Project: Fillmore High School Modernization

Project Number: WGD 20624 DSA# 03-121233

Addendum 03 – Mechanical Unit Replacement

Date: September 8, 2023

M0-1.1 – Mechanical Schedules

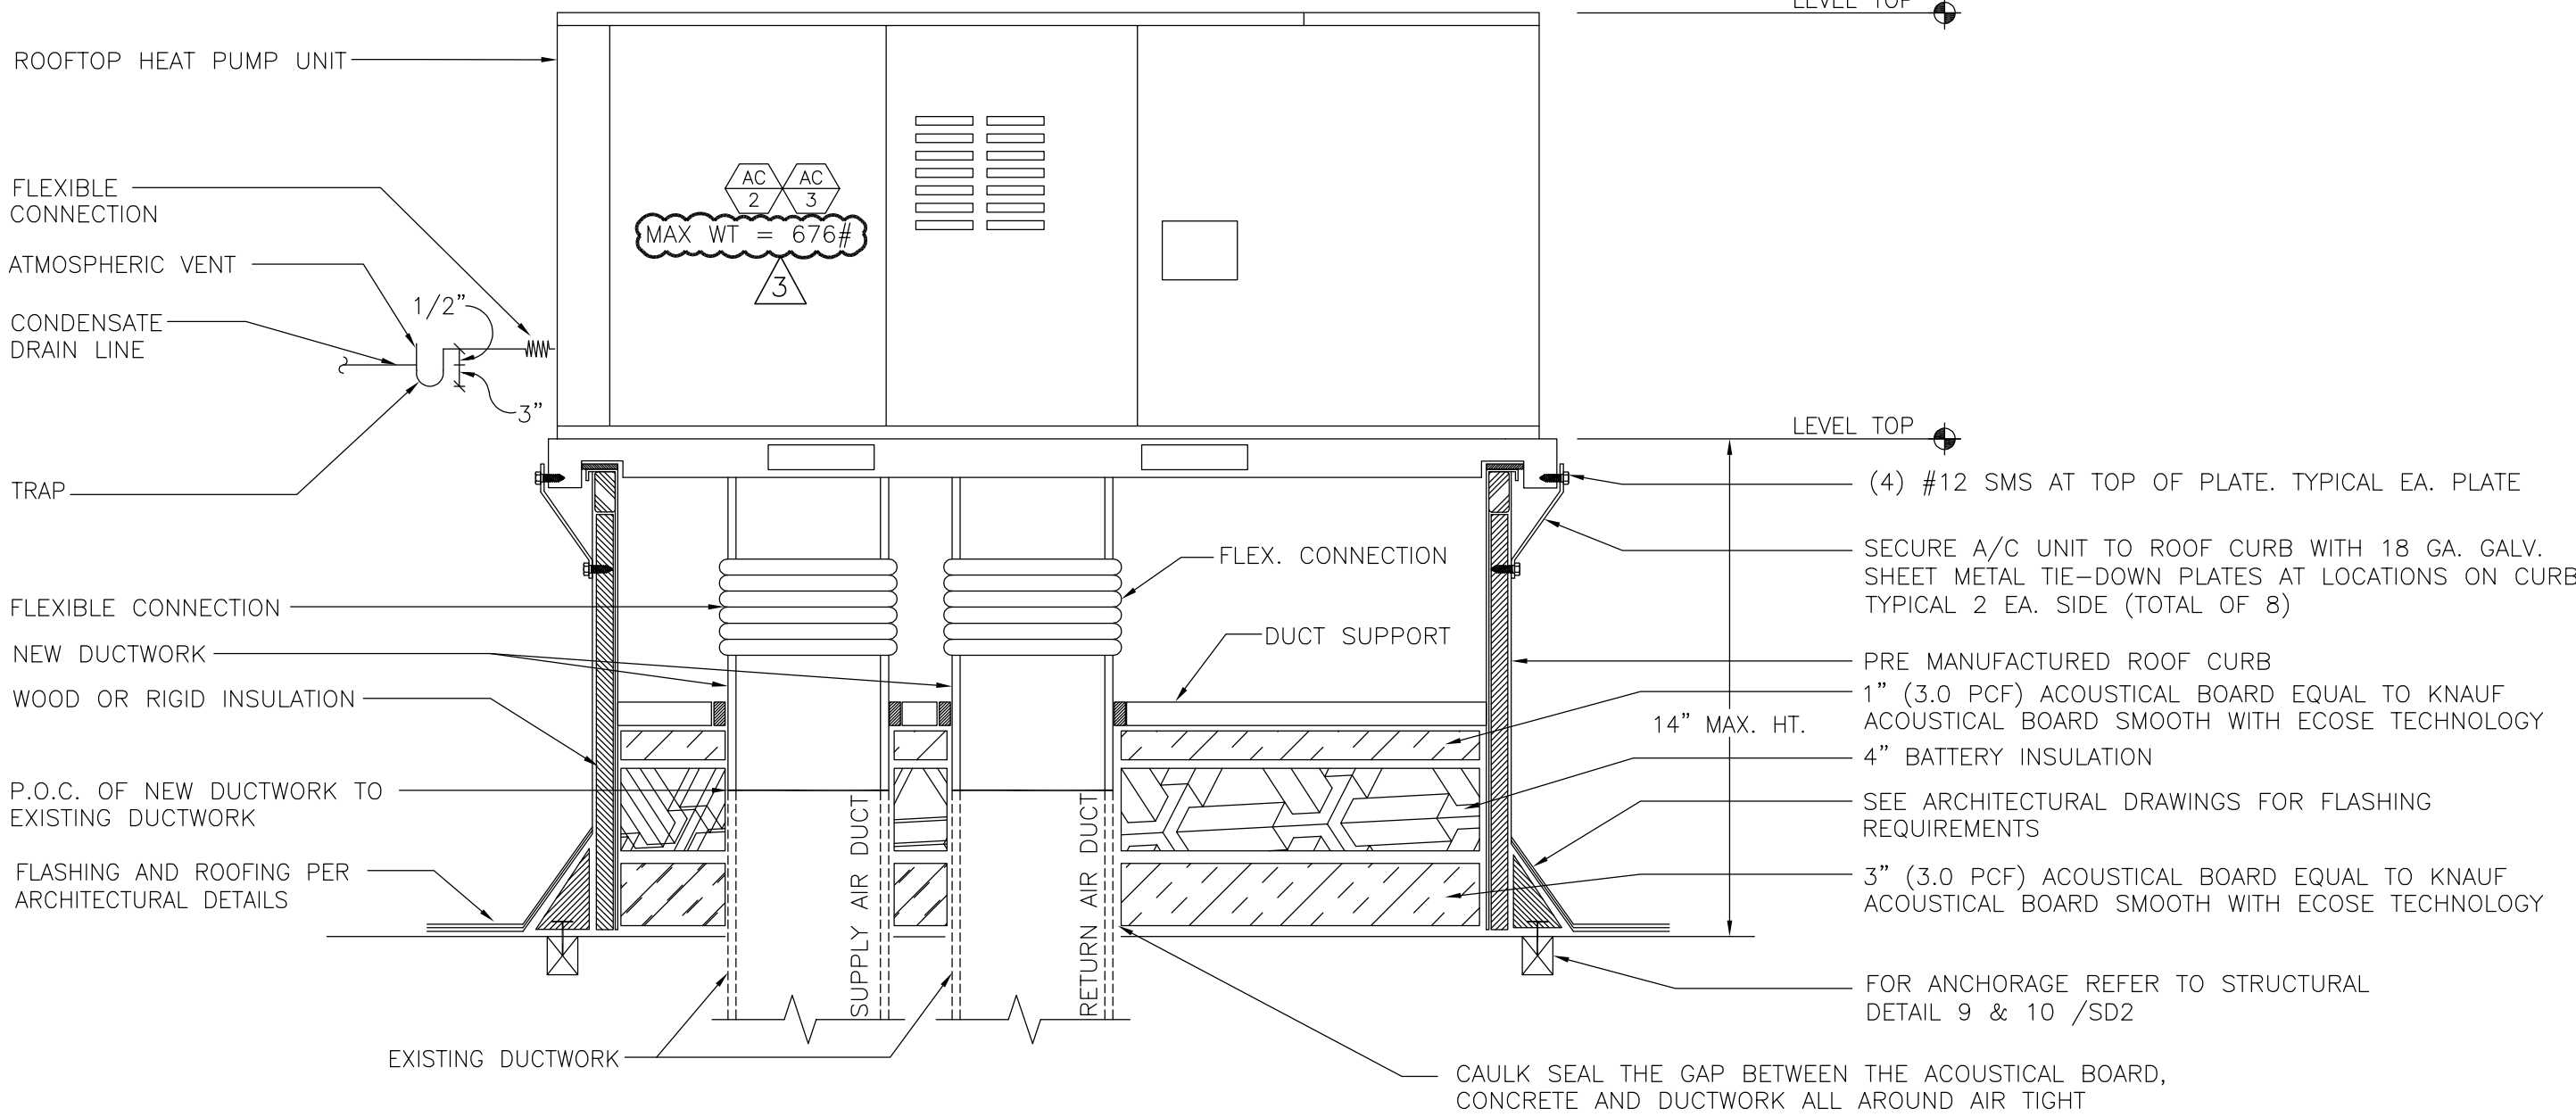
- a. Revised AC-1, AC-2 and AC-3 model numbers and associated parameters on the “Heat Pump Schedule (Packaged).”
- b. Revised the “Existing Heat Pump and New Heat Pump Comparison Schedule.”

M0-1.2 – Mechanical Details

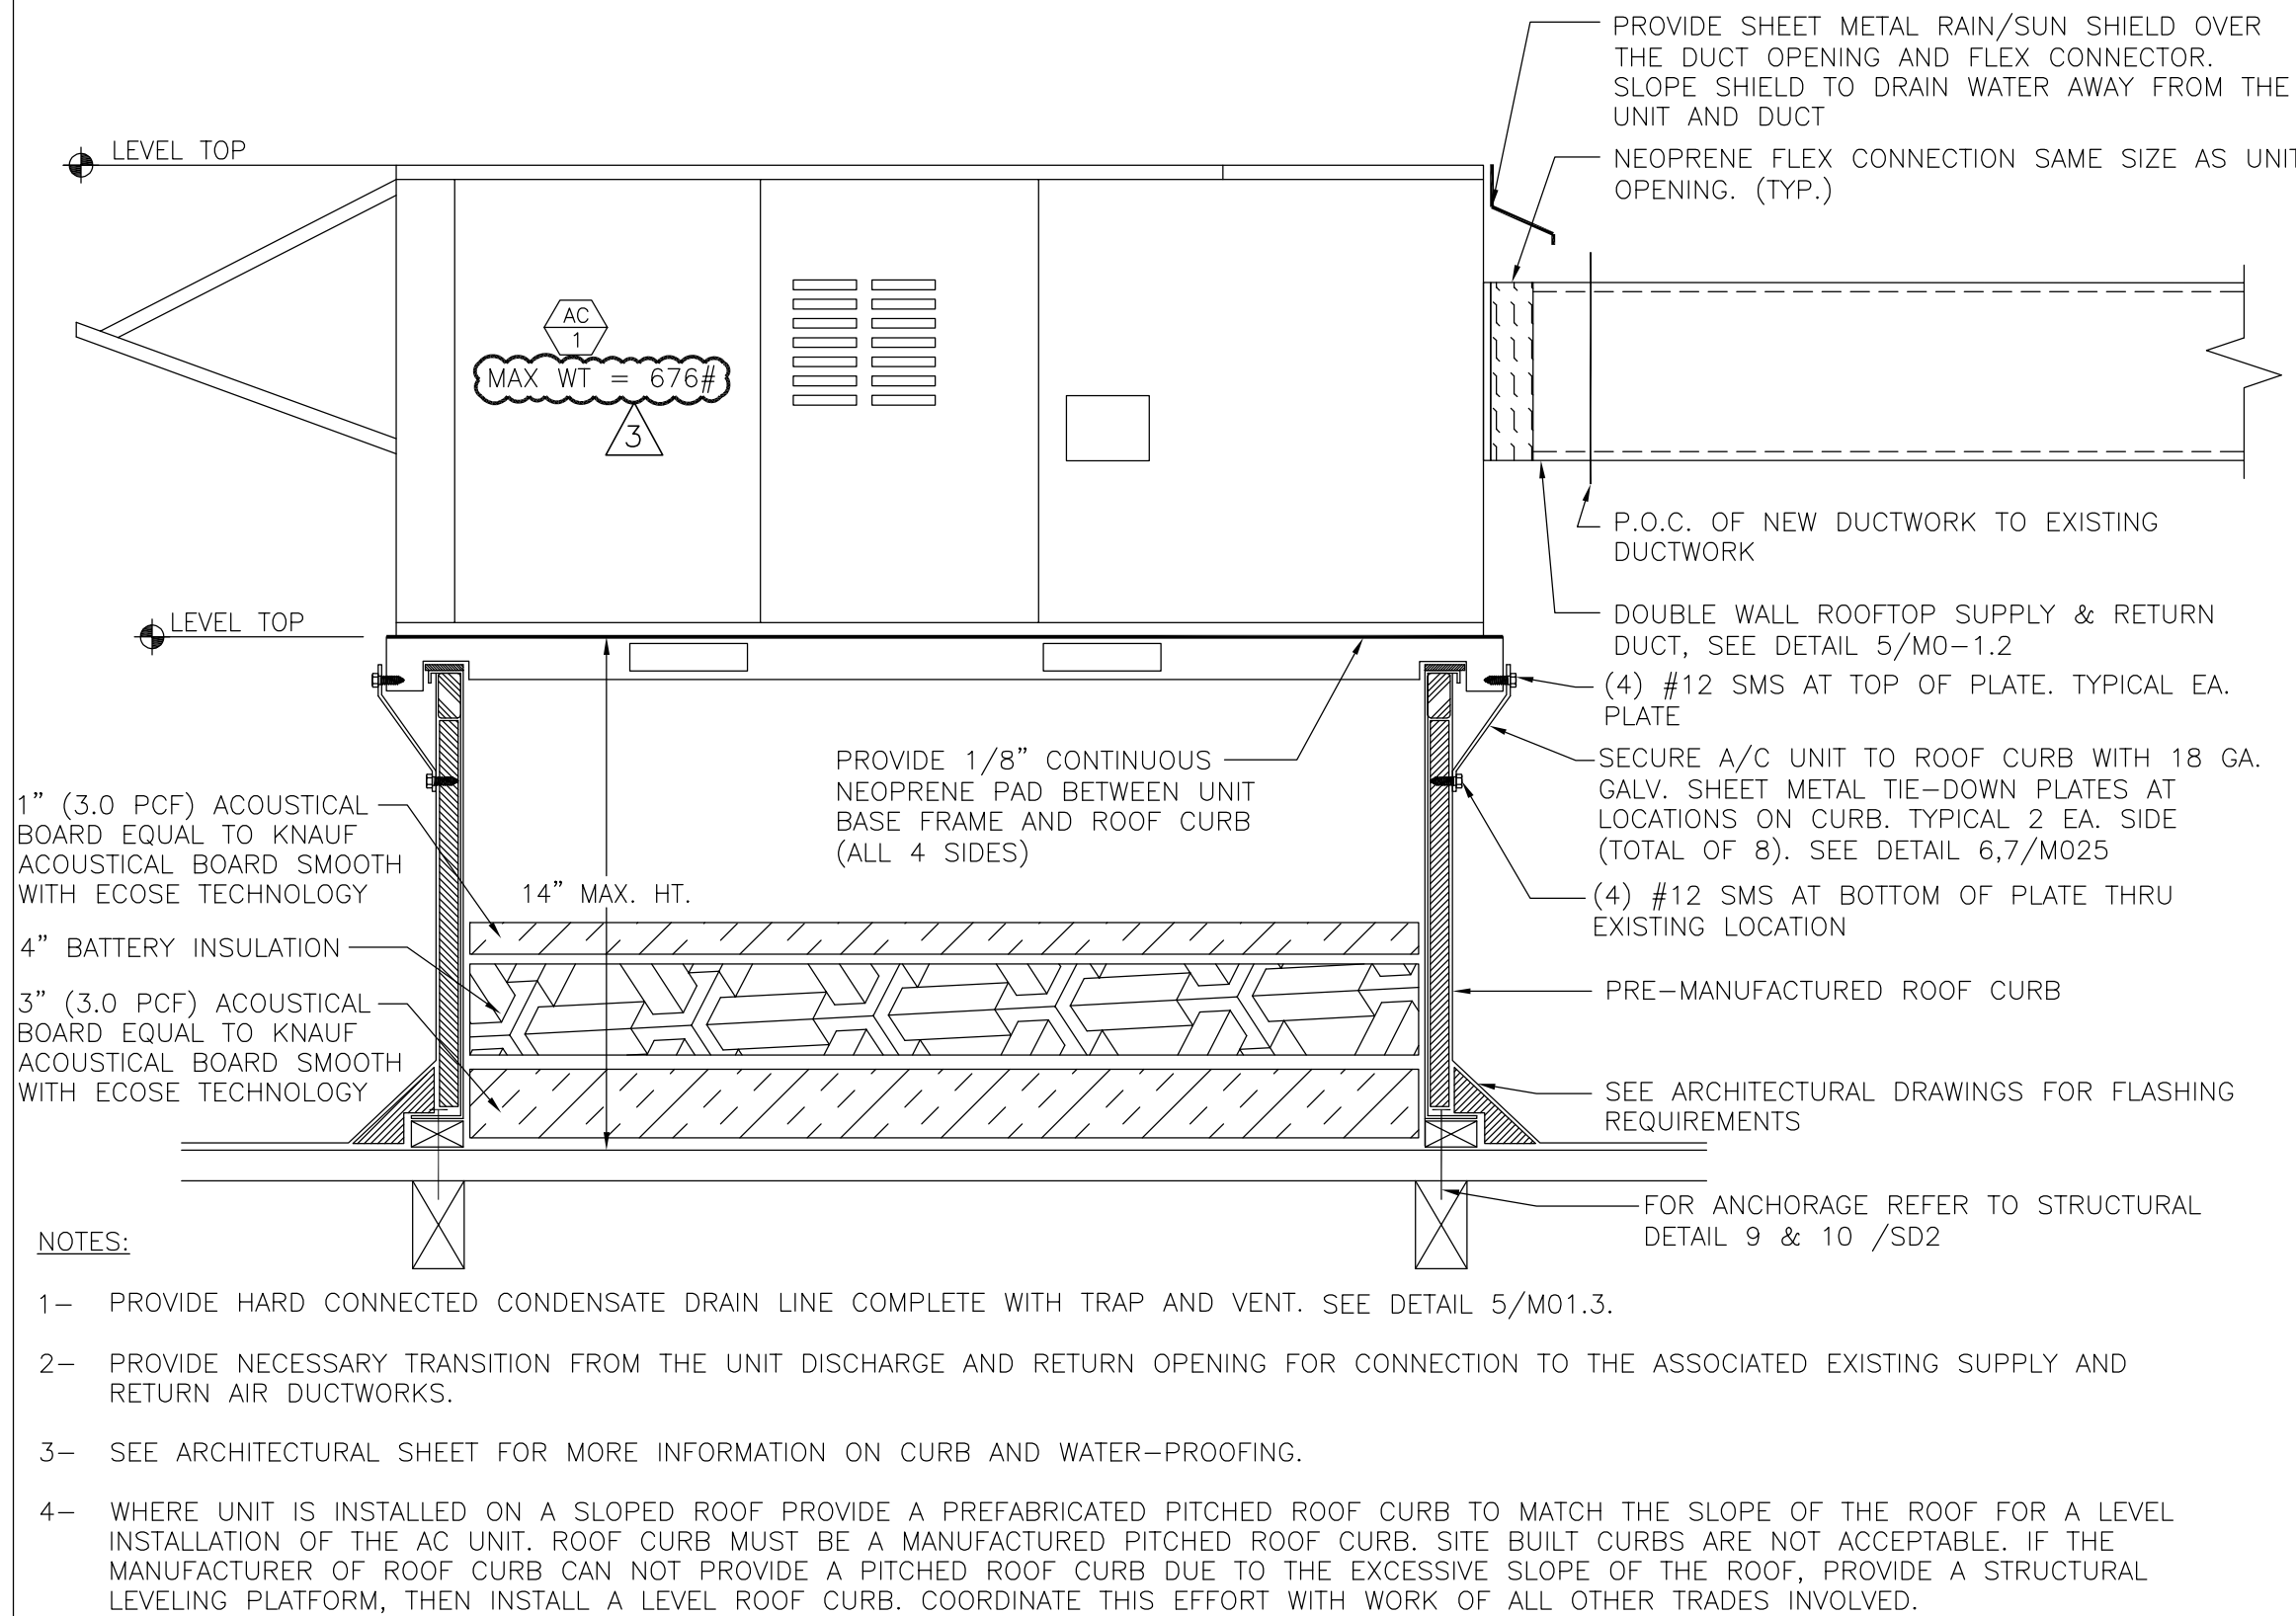
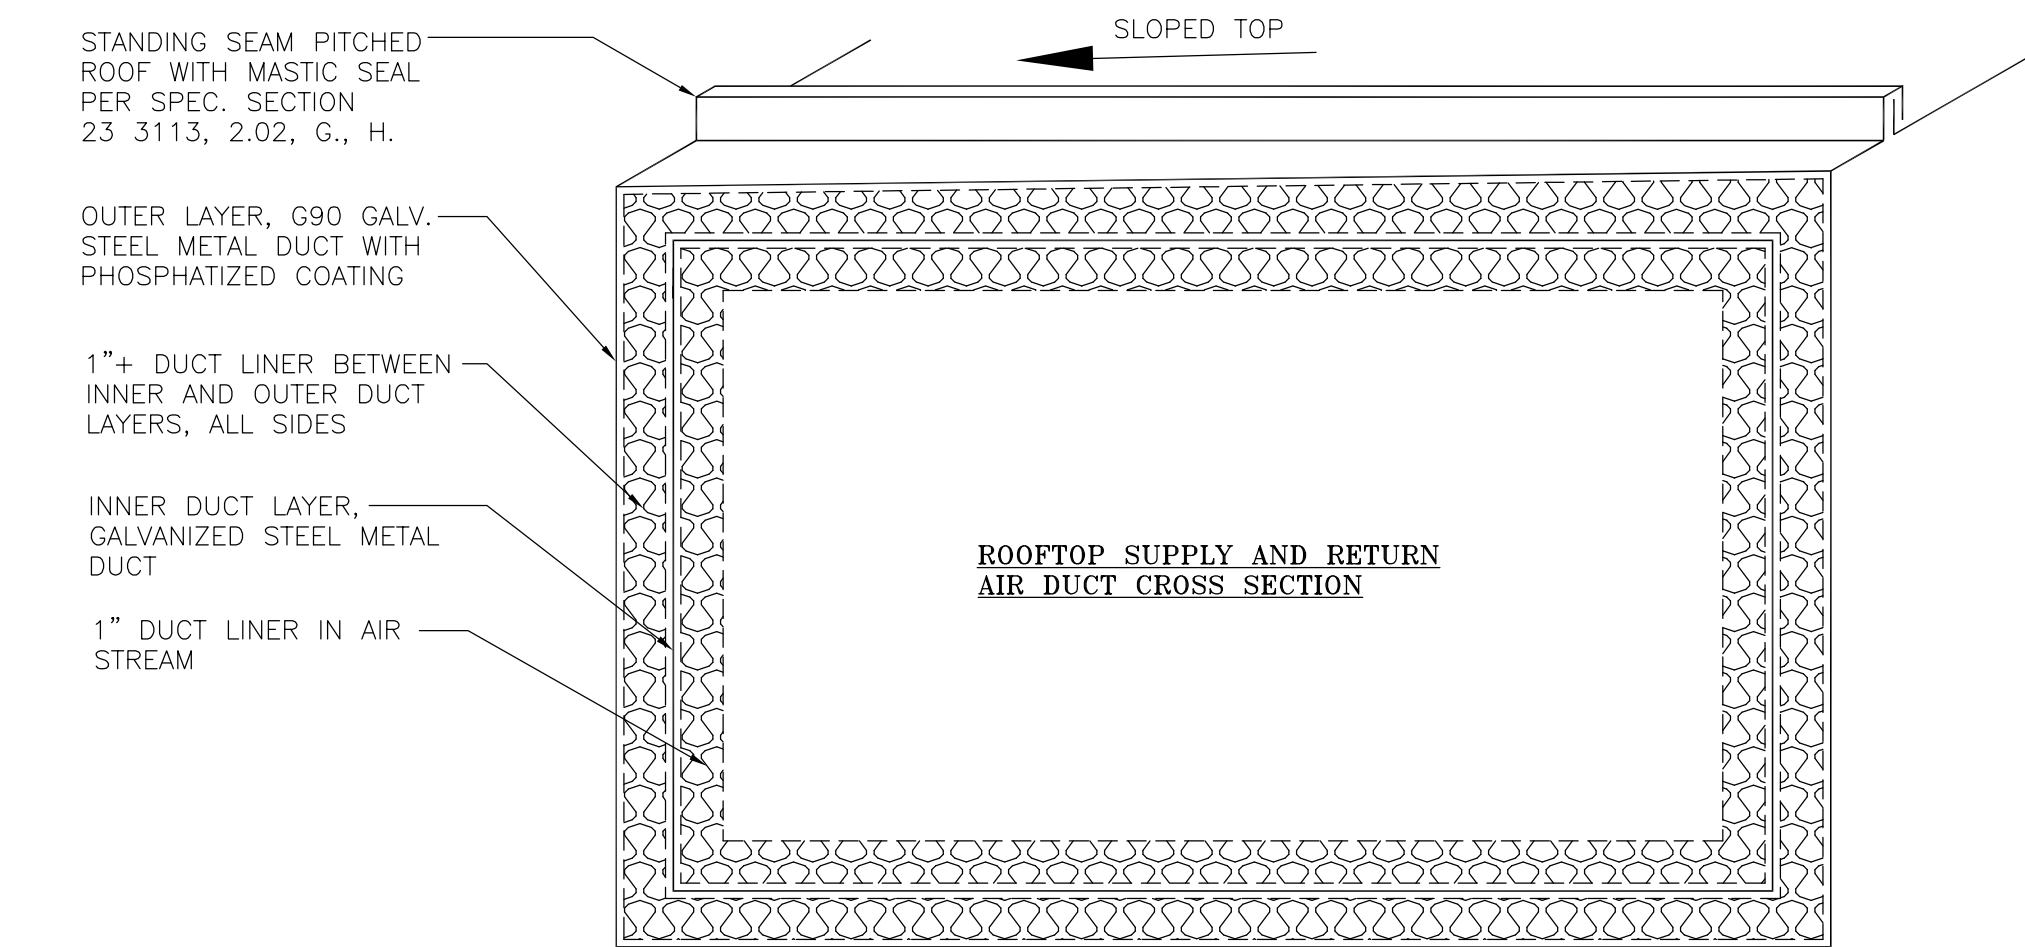
- a. Revised the operating weights on details #2 and #3.
